Storage J10 Plan 1 : 20

SPECIFICATIONS - Storage J10
RHK6581 Lee Smith

Kitchens By Resident Hero 32 Gateway Drive Phone: 0754471077 mark@residenthero.com.au www.residenthero.com.au	RHK6581 Lee Smith	**Scale: 1 : 20**	**Sheet 1 of 3**
	Storage J10	Do not scale off this drawing.	Drawn By:
	38 Howard St, Grange QLD		Date: 26/10/26

Storage J10 Elevation Wall 1 1 : 20

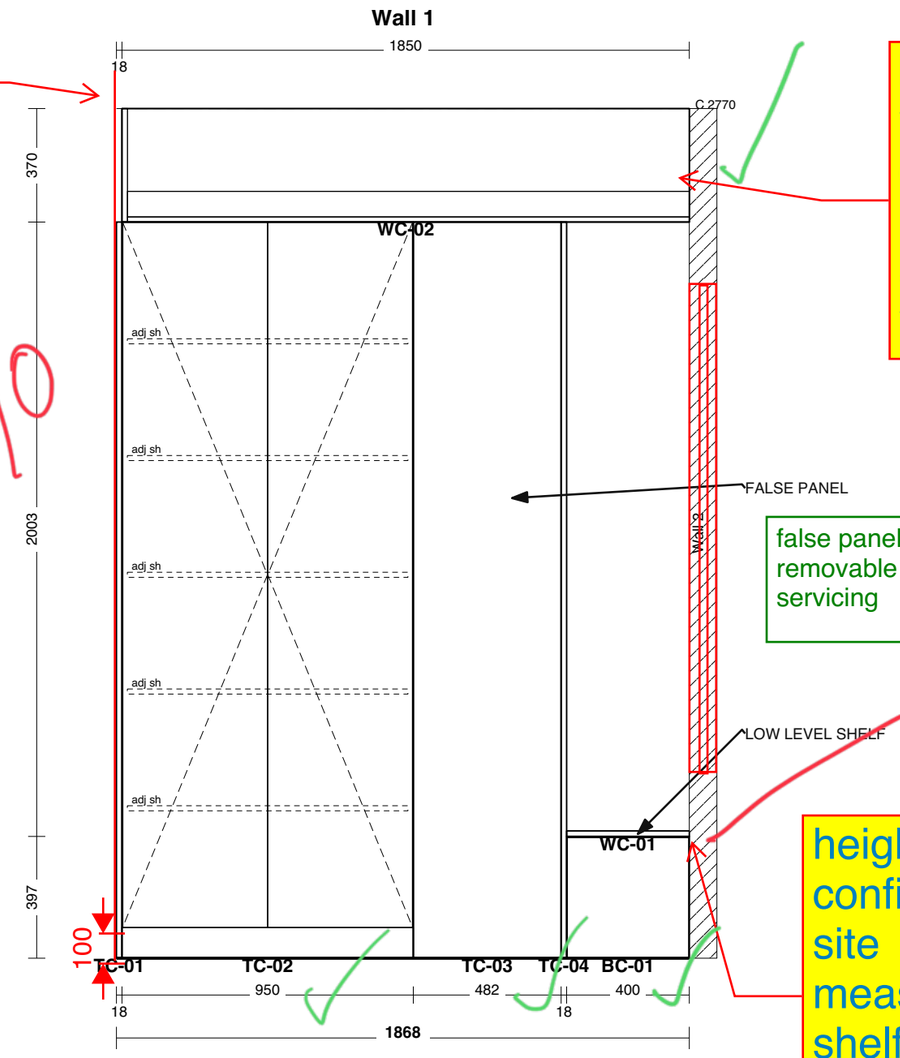
flush finish to visible end of joinery

bulkhead to wall will need to be confirmed at site measure. There is a window in this wall

false panel to be removable for servicing

height to be confirmed at site measure. shelf to sit below window sill
